February 22, 1994  
LD-94-012

Docket No. 52-002

Subject: System 80+™ Information for Issue Closure

The attachments to this letter provide material to close follow-on questions to DSER responses. Attachment 1 provides minor revisions to Section 1.4 of CESSAR-DC in response to a comment from Mr. T. Boyce.

Figure 3.7D-42

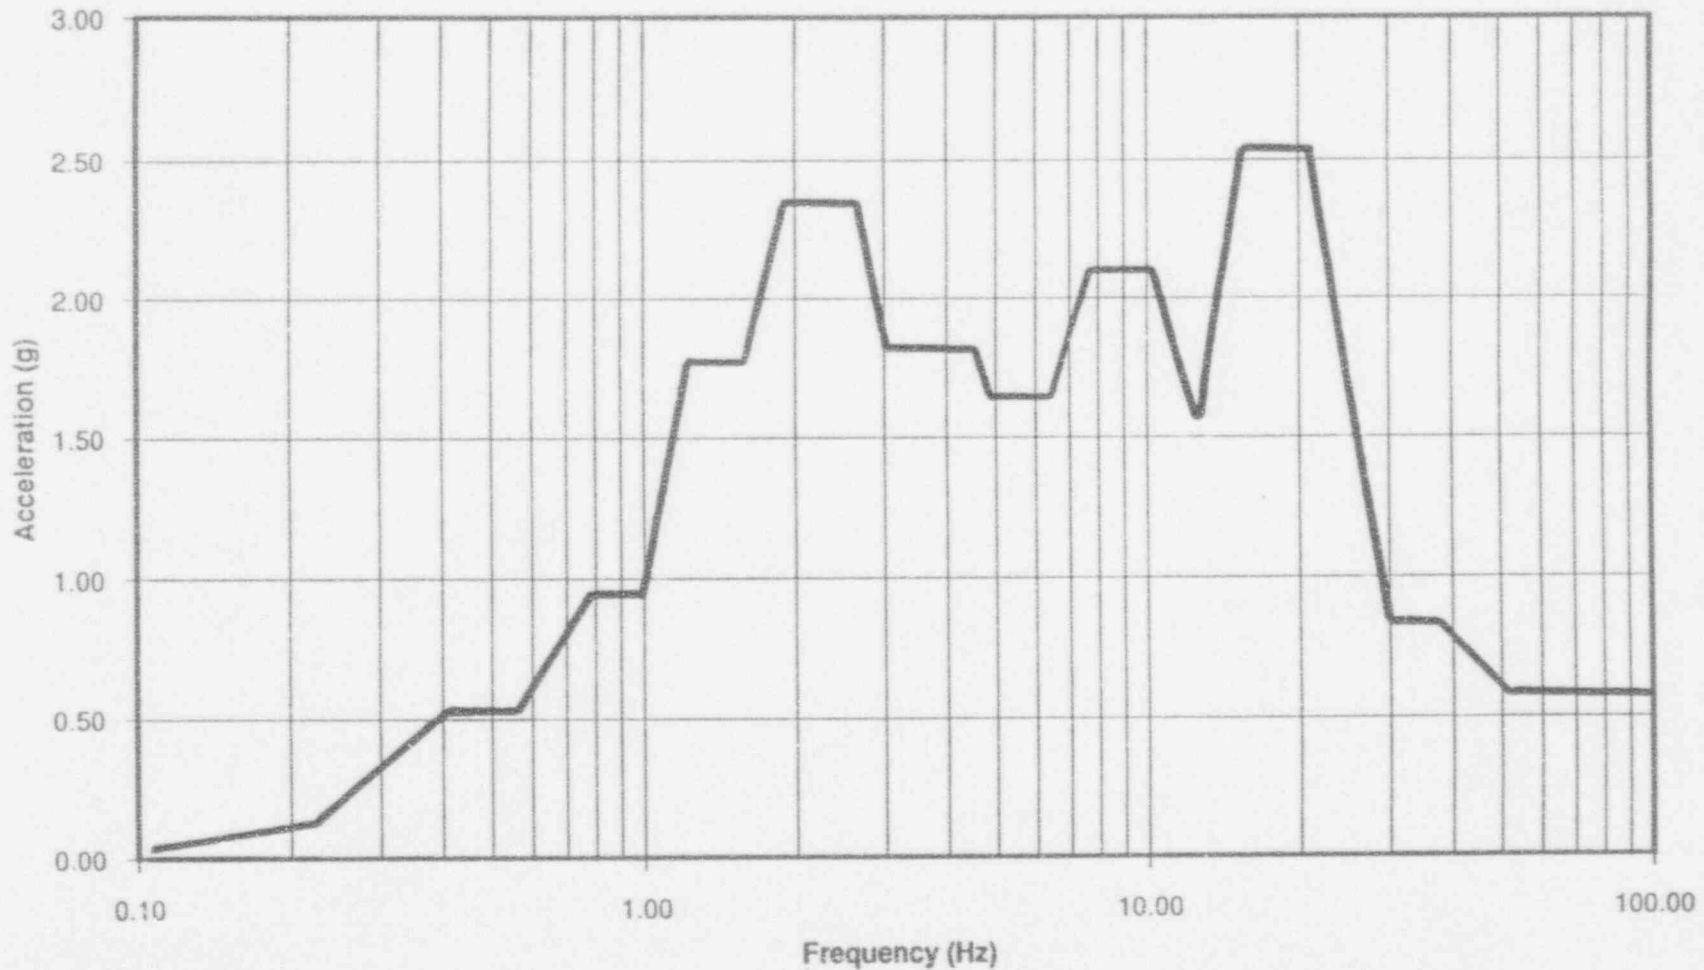
*Broadened*  
CE System 80+ <sup>UM</sup> Response Spectra at Elev. 91.75' of CCW <sup>HEB</sup>, All Soil Cases, All Motions,  
Horizontal Model, H1 Motion (E-W), 5% Damping  
*E-W Direction*

Figure 3.7D-43

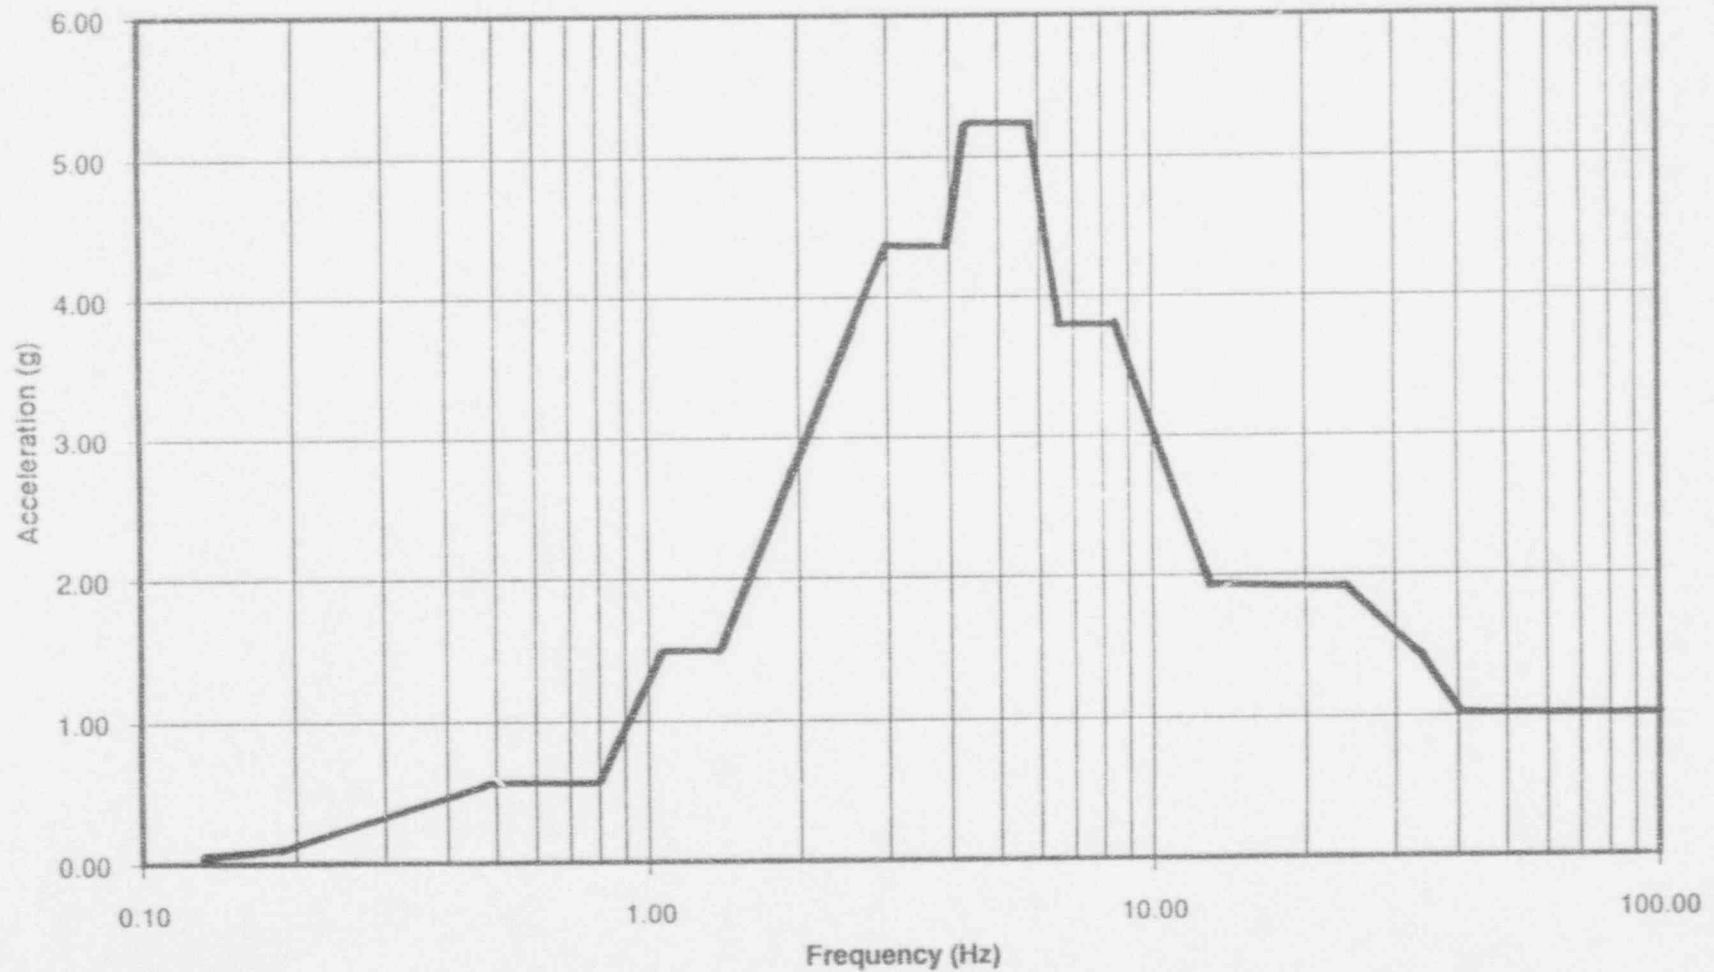
*Broadened*

*HEB*

**CE System 80+ Response Spectra<sup>um</sup> at Elev. 91.75' of CCW, All Soil Cases, All Motions,  
Horizontal Model, H2 Motion (N-S), 5% Damping  
*N-S Direction***

Figure 3.7D-44

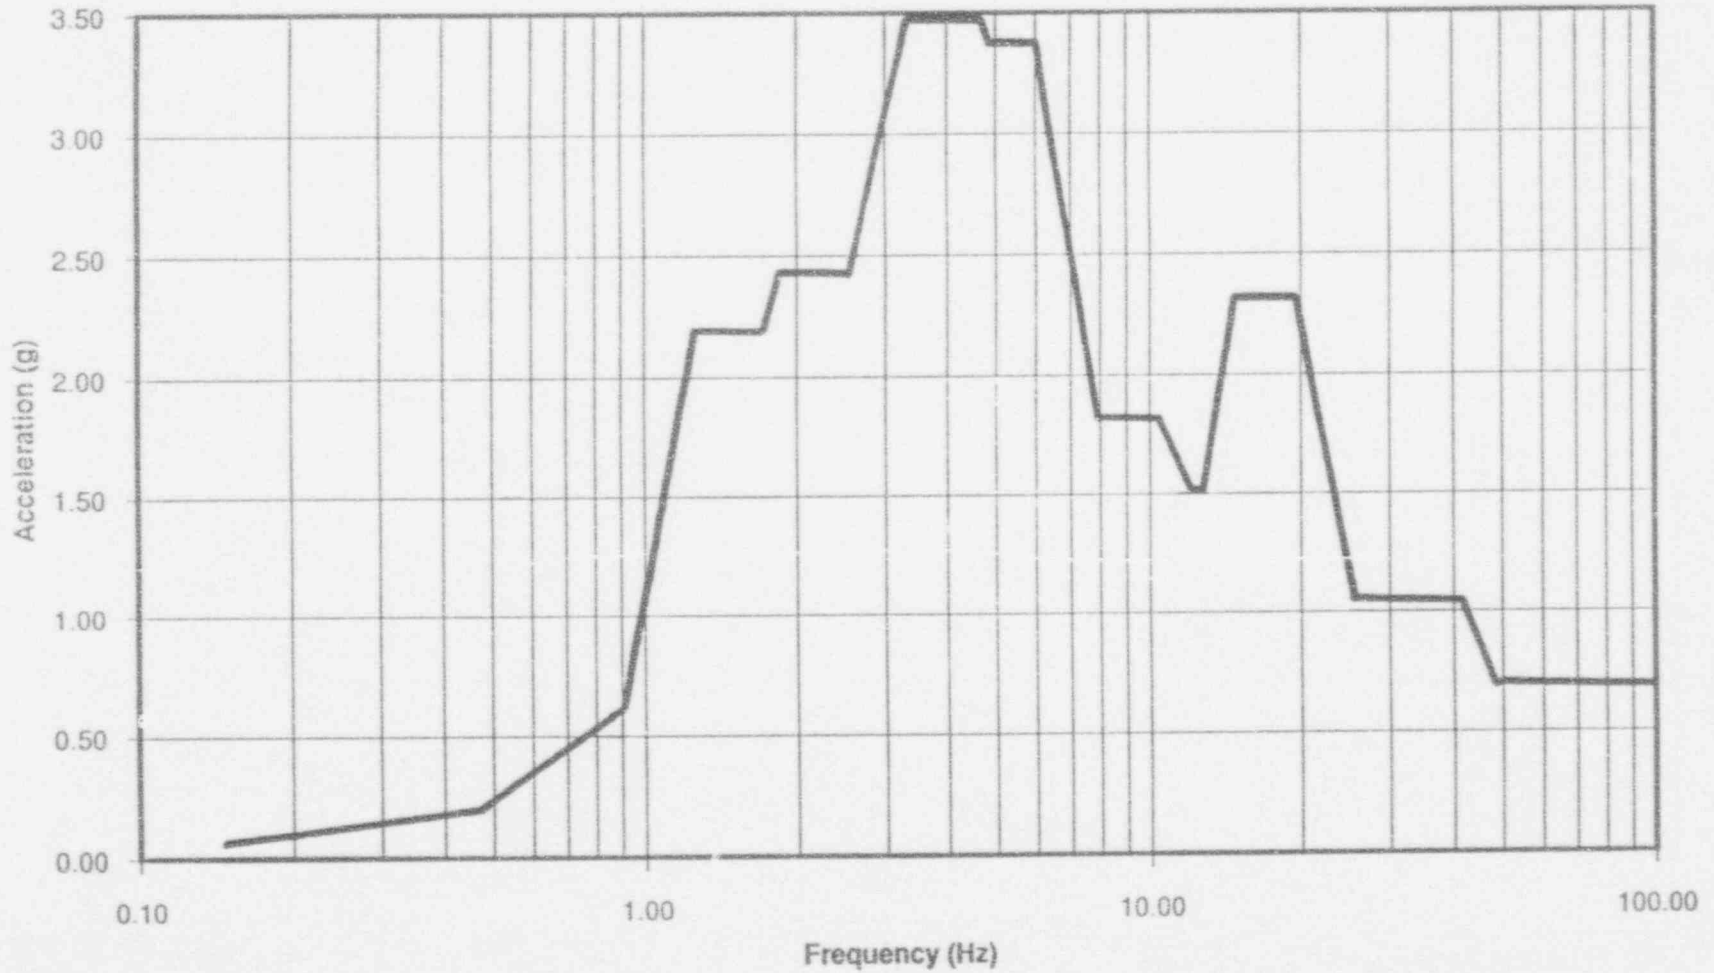
*Broadened*

CE System 80+ Response Spectra at Elev. 91.75' of CCW, All Soil Cases, All Motions,  
Vertical Model, 5% Damping

Figure 3.7D-45

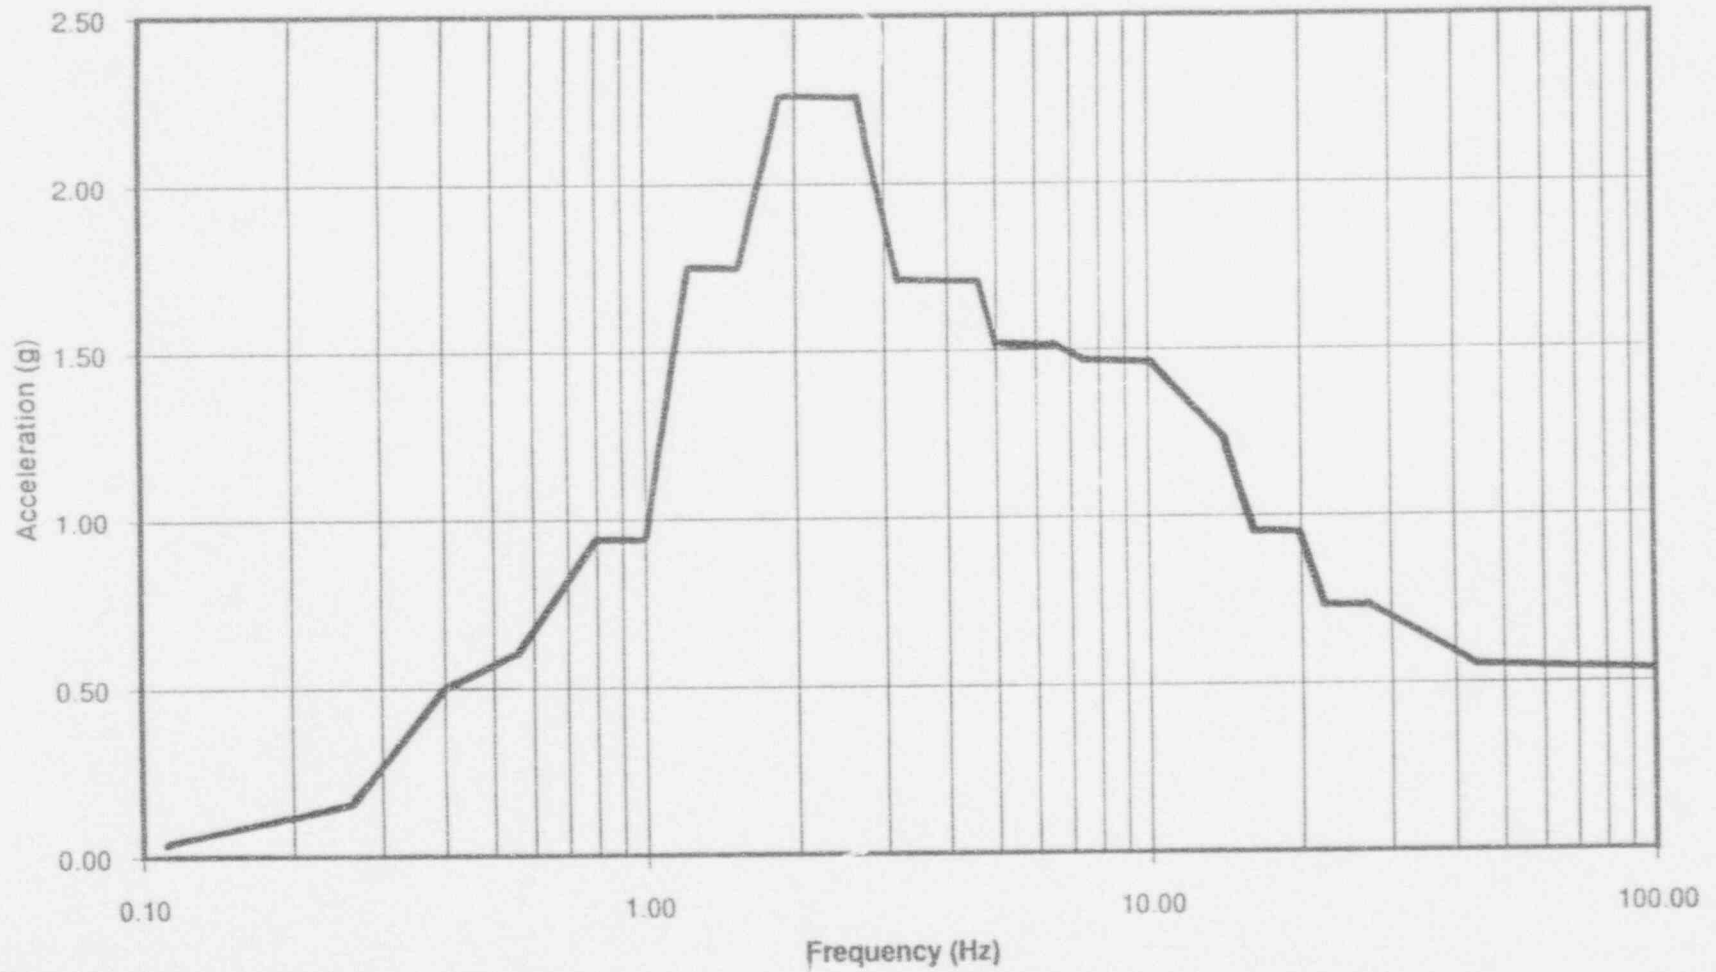
*Broadened*  
CE System 80+ <sup>UM</sup> Response Spectra at Elev. 78.25' of DFSS, All Soil Cases, All Motions,  
Horizontal Model, H1 Motion (E-W), 5% Damping  
*E-W Direction*

Figure 3.7D-46

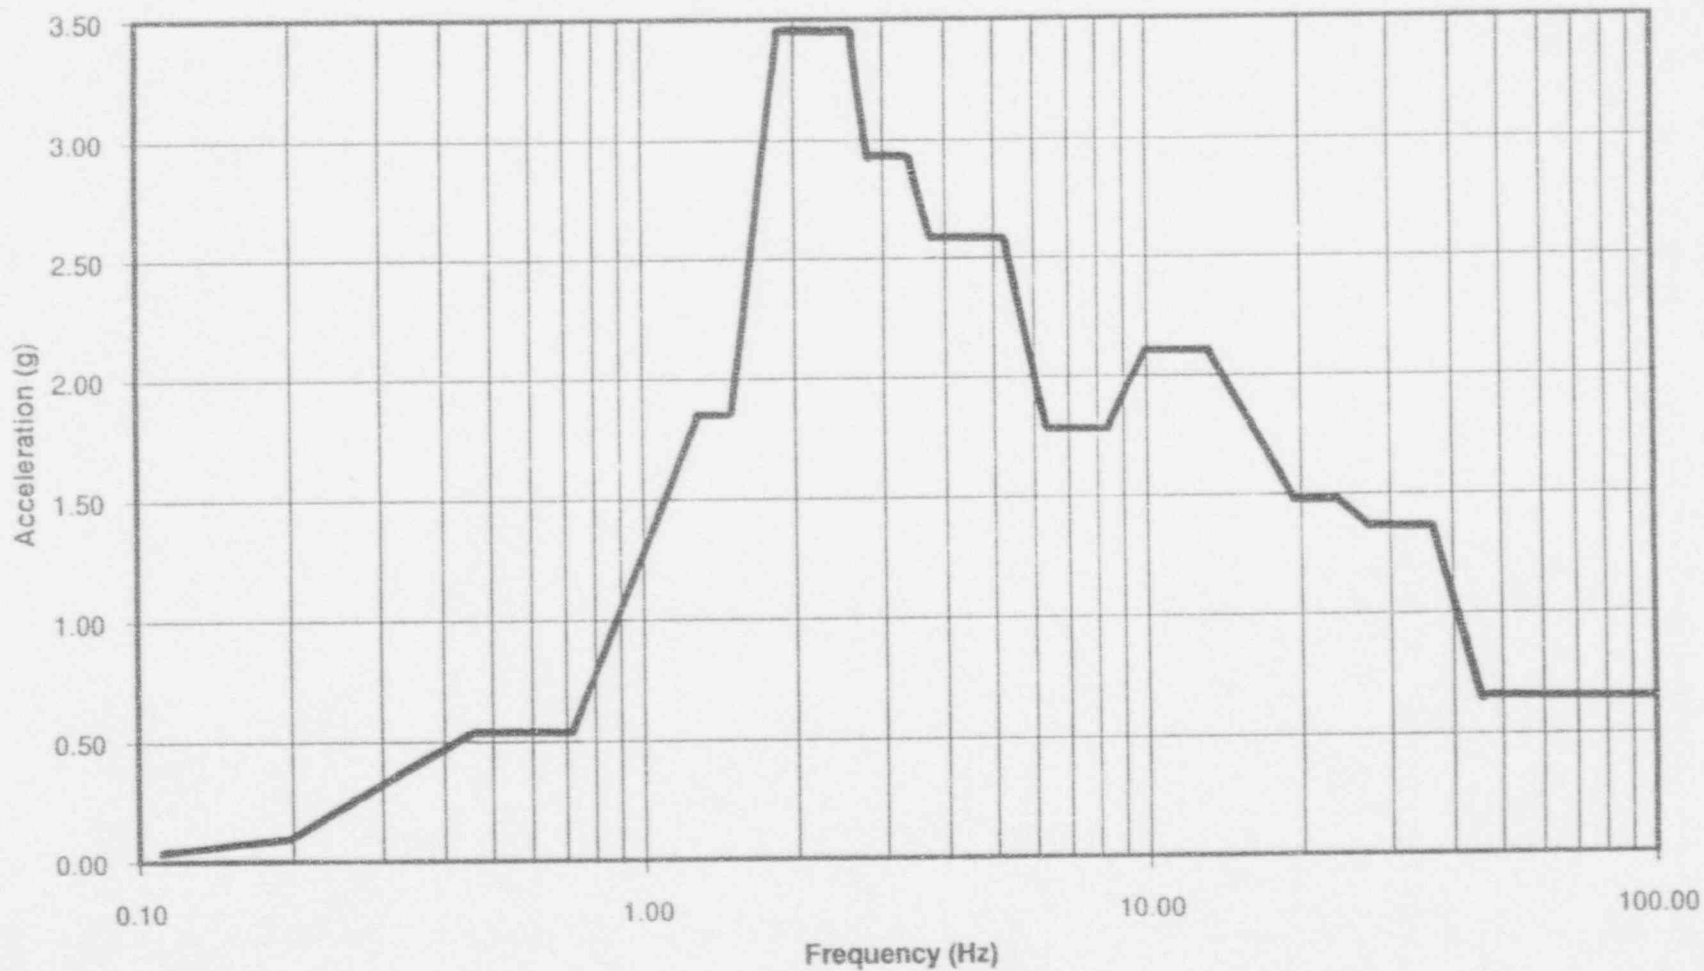
Broadened

CE System 80<sup>401</sup> Response Spectra at Elev. 78.25' of DFSS, All Soil Cases, All Motions,  
Horizontal Model, H2 Motion (N-S), 5% Damping  
N-S Direction

Figure 3.7D-47

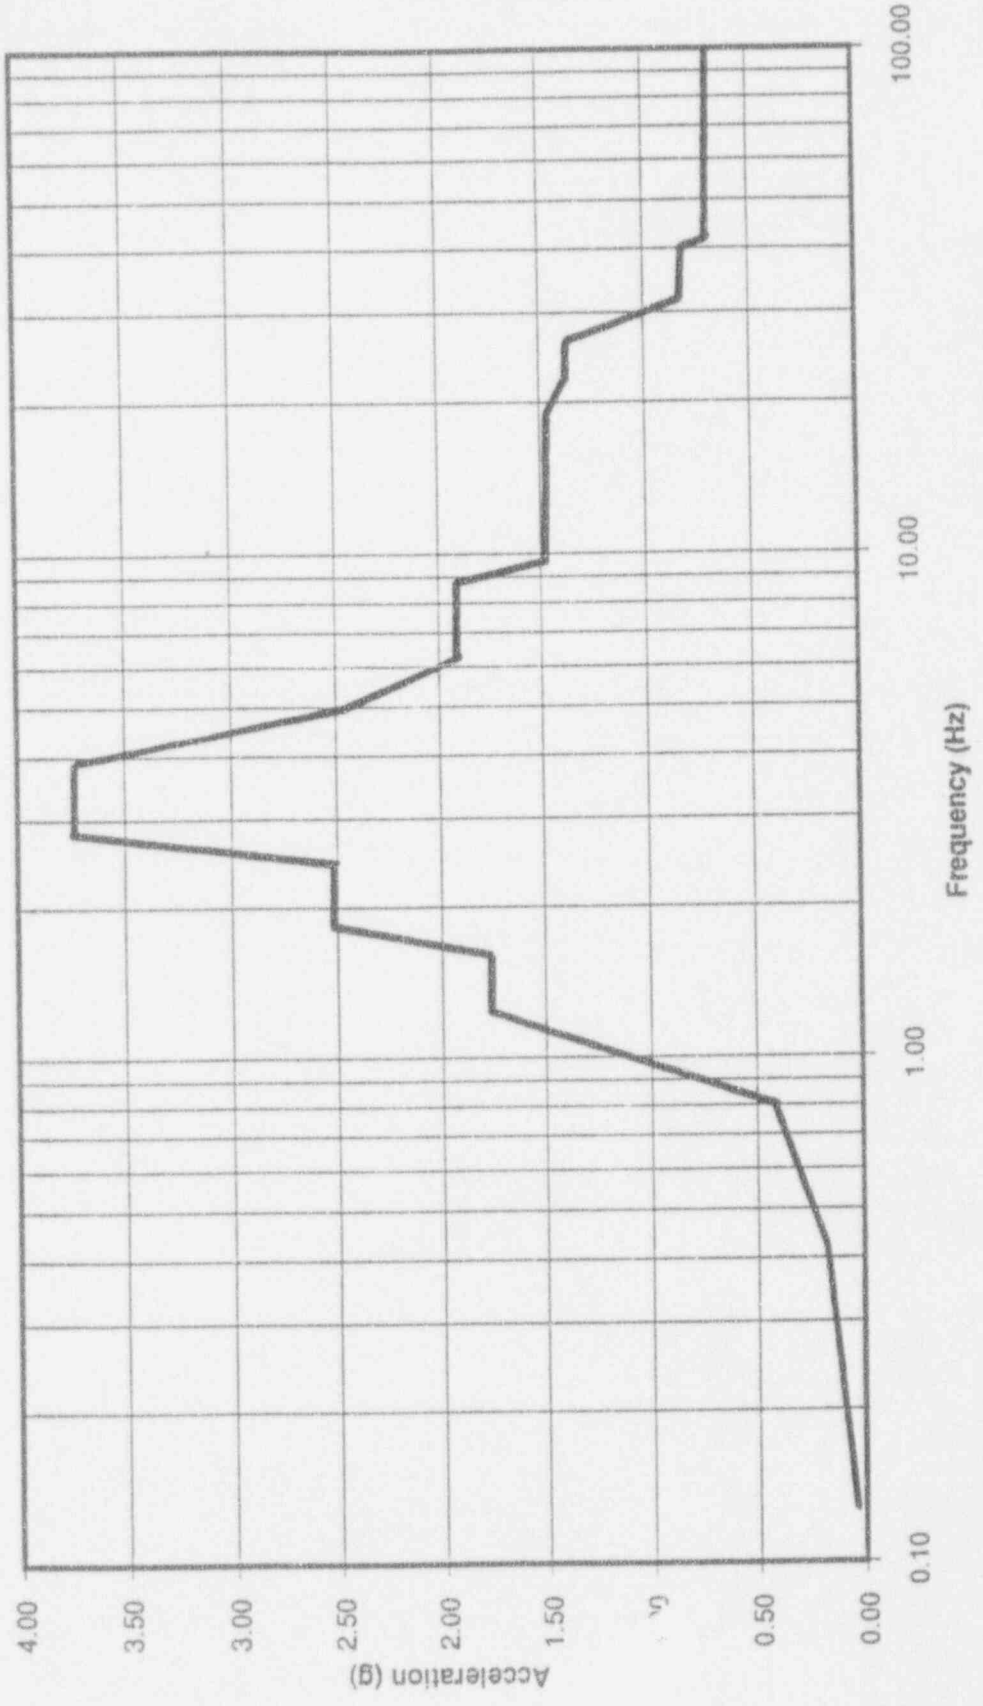
*Broadened*  
CE System 80+ Response Spectra at Elev. 78.25' of DFSS, All Soil Cases, All Motions,  
Vertical Model, 5% Damping  
*Direction*
